Technical Service Bulletin

01 MIL on, Whistling noise, leaking air Bank 2 - DTC P2ADF00, Engine Crankcase breather

01 23 78 2071318/2 September 20, 2023. Supersedes Technical Service Bulletin Group 01 number 23-72 dated August 23, 2023 for reasons listed below.

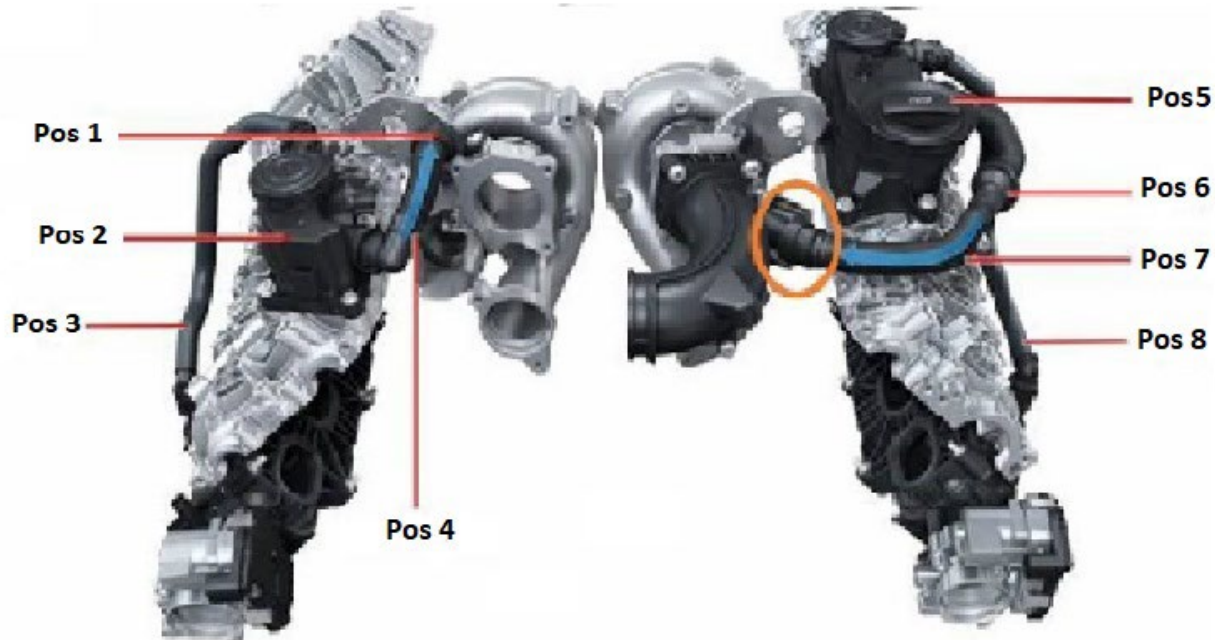
In this case, replace the full load breather line for cylinder bank 2.

1. Do not replace the oil separator for bank 1 or bank 2 or the part load breather lines.
 - a. Please refer to image of the crankcase from the Self Study Program 920493 as a guide.

- Item 1: Non-return valve
- Item 2: Oil separator for bank 1
- Item 3 Part load breather line for bank 1
- Item 4: Full load breather line for bank 1
- Item 5: Oil separator for bank 2
- Item 6: Non-return valve
- **Item 7: Full load breather line for bank 2**
- Item 8: Part load breather line
